Form 3160-5
(June 2019)UNITED STATES
DEPARTMENT OF THE INTERIOR
BUREAU OF LAND MANAGEMENTFORM APPROVED
OMB No. 1004-0137
Expires: October 31, 2021**SUNDRY NOTICES AND REPORTS ON WELLS**
Do not use this form for proposals to drill or to re-enter an abandoned well. Use Form 3160-3 (APD) for such proposals.5. Lease Serial No. **NMNM14785**
6. If Indian, Allottee or Tribe Name**SUBMIT IN TRIPLICATE - Other instructions on page 2**

8. Well Name and No. **BRUSHY DRAW 30 FEDERAL/703F**9. API Well No. **3001545195**10. Field and Pool or Exploratory Area
Wildcat11. Country or Parish, State
EDDY/NM**12. CHECK THE APPROPRIATE BOX(ES) TO INDICATE NATURE OF NOTICE, REPORT OR OTHER DATA**

****Spacing, Casing/Cement, Drilling Variance Changes**

XTO Permian Operating, LLC requests permission to make the following changes to the original APD:

WELL LOCATION AND ACREAGE DEDICATION PLAT

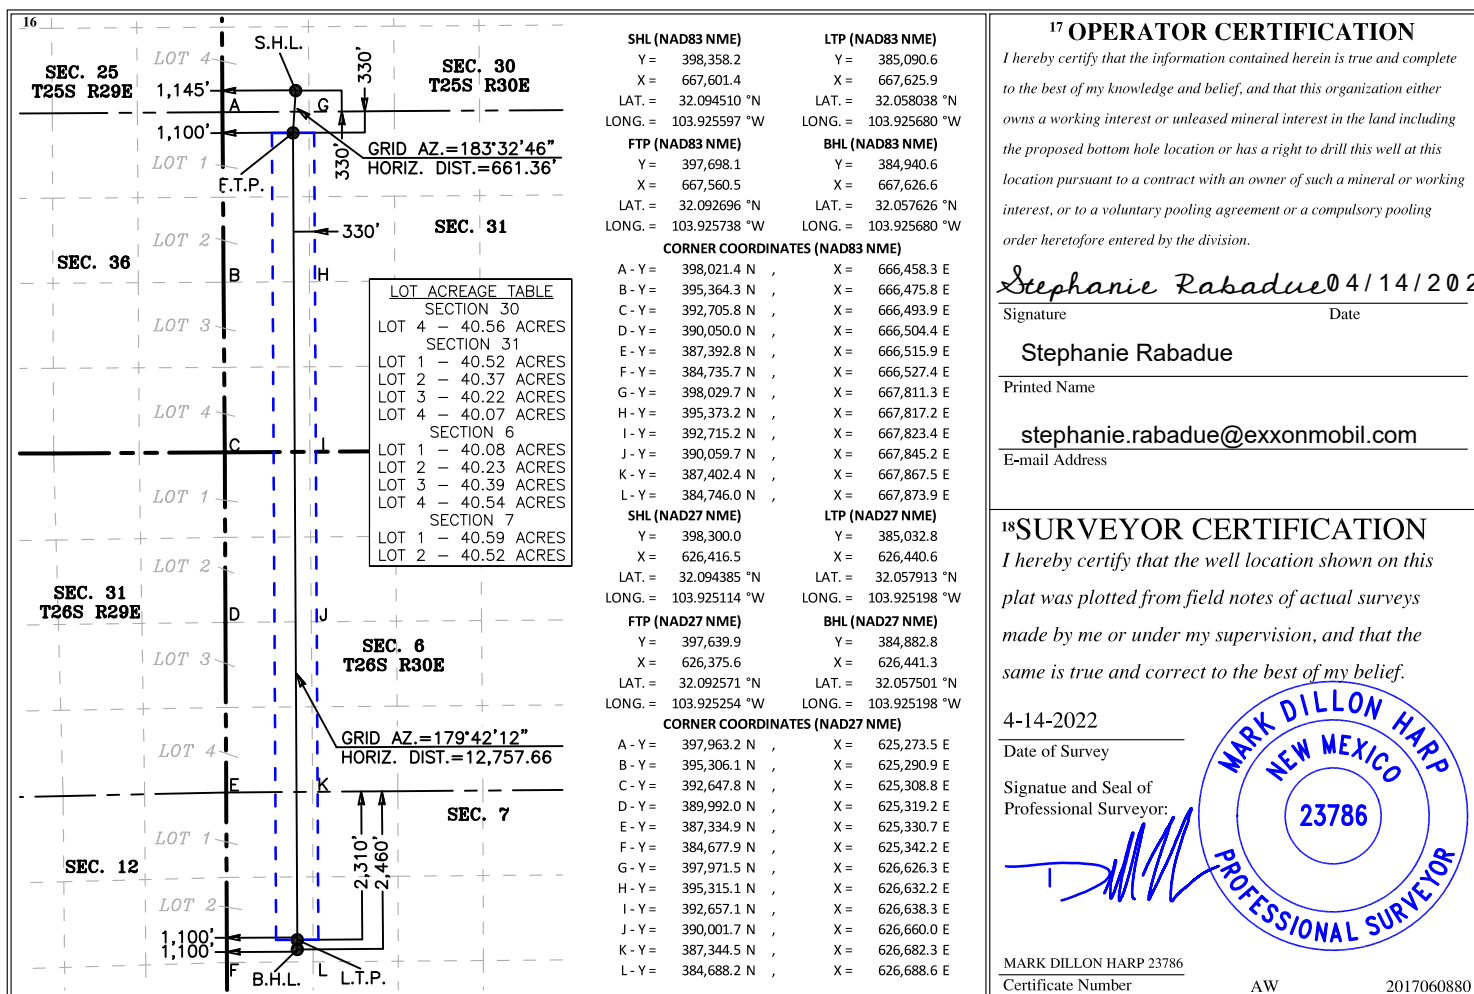
Change BHL fr/2440FNL & 1650FWL to 2460FNL & 1100FWL

UL or lot no.	Section	Township	Range	Lot Idn	Feet from the	North/South line	Feet from the	East/West line	County
2	7	26 S	30 E		2,460	NORTH	1,100	WEST	EDDY

Note: Picture below highlights BOP components that will be tested during batch operations

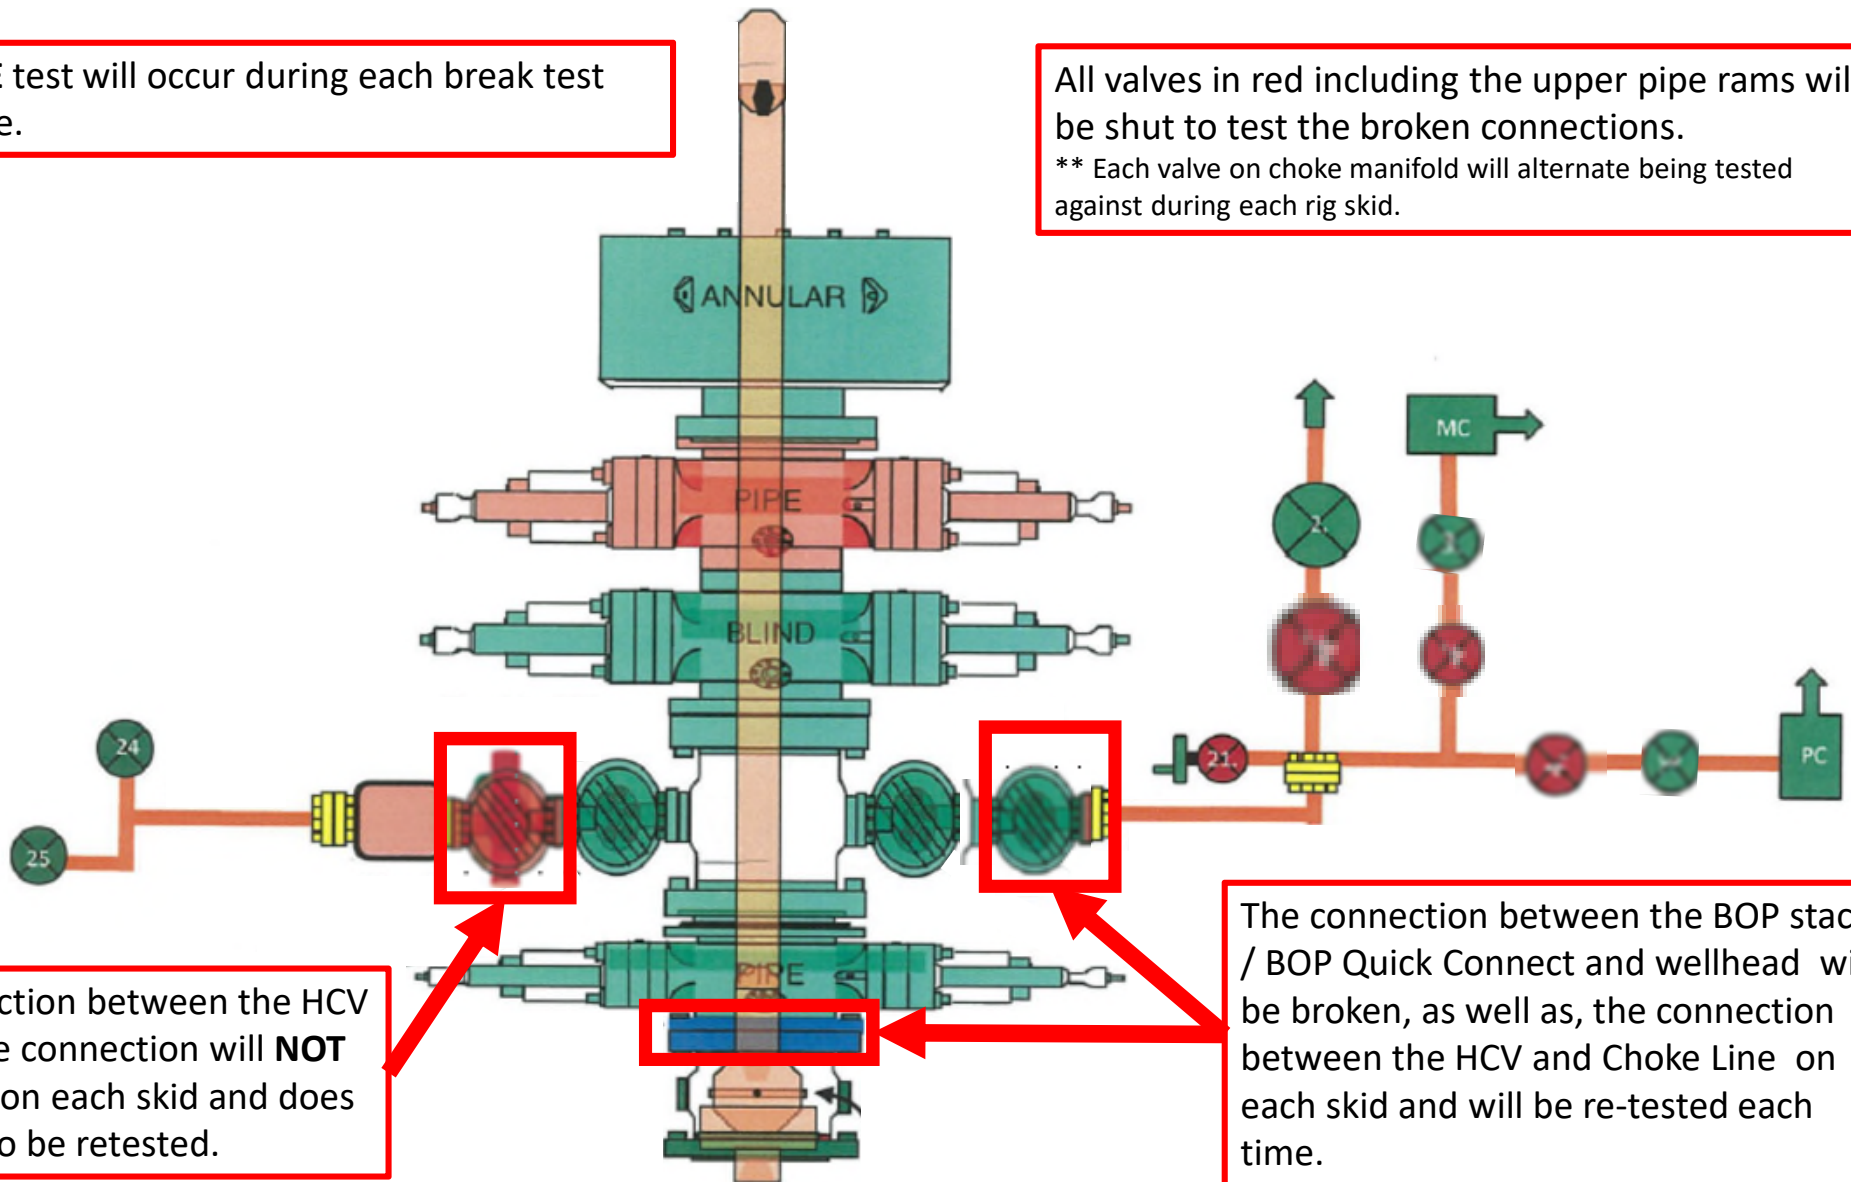
Only **ONE** test will occur during each break test procedure.

All valves in red including the upper pipe rams will be shut to test the broken connections.

** Each valve on choke manifold will alternate being tested against during each rig skid.

The connection between the HCV and kill line connection will **NOT** be broken on each skid and does not need to be retested.

The connection between the BOP stack / BOP Quick Connect and wellhead will be broken, as well as, the connection between the HCV and Choke Line on each skid and will be re-tested each time.

Wellhead diagram during skidding operations

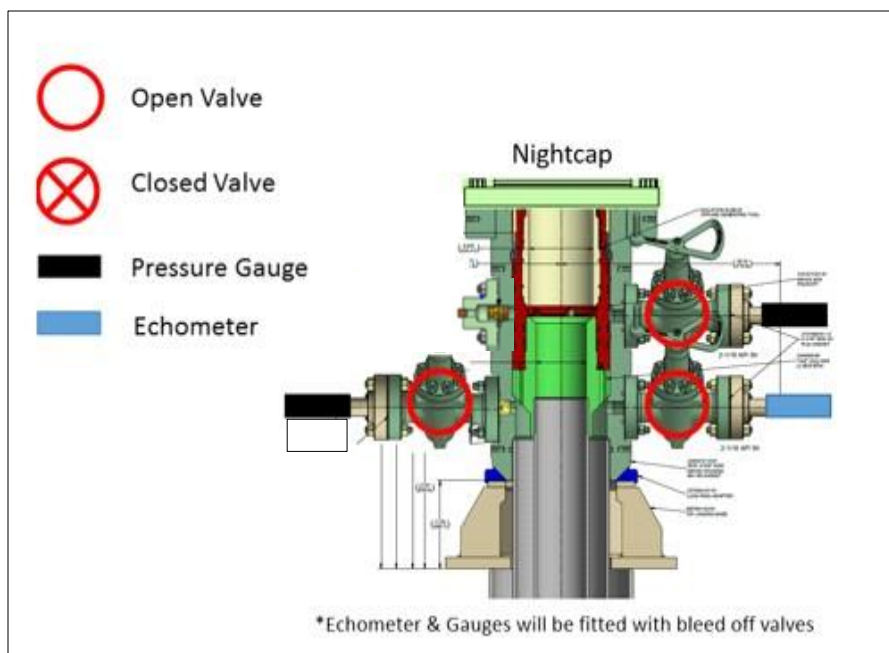
6. Skid rig to next well on pad.
7. Confirm well is static before removing cap flange, flange will not be removed and offline cementing operations will not commence until well is under control. If well is not static, casing outlet valves will provide access to both the casing ID and annulus. Rig or third party pump truck will kill well prior to cementing or nipping up for further remediation.

Wellhead diagram during offline cementing operations

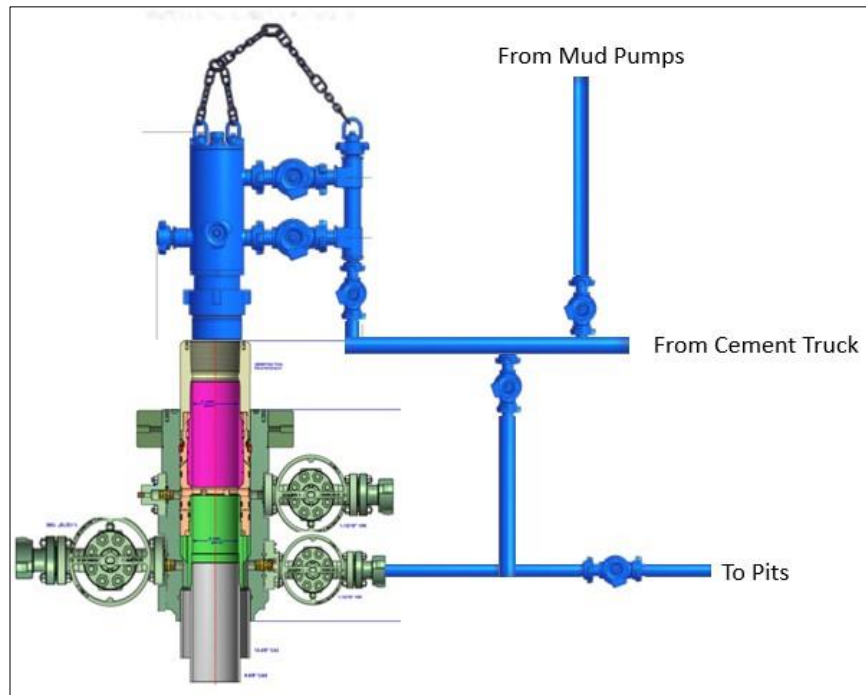
10. Circulate bottoms up with cement truck
 - a. If gas is present on bottoms up, well will be shut in and returns rerouted through gas buster to handle entrained gas
 - b. Max anticipated time before circulating with cement truck is 6 hrs
11. Perform cement job taking returns from the annulus wellhead valve
12. Confirm well is static and floats are holding after cement job
13. Remove cement equipment, offline cement tools and install night cap with pressure gauge for monitoring.
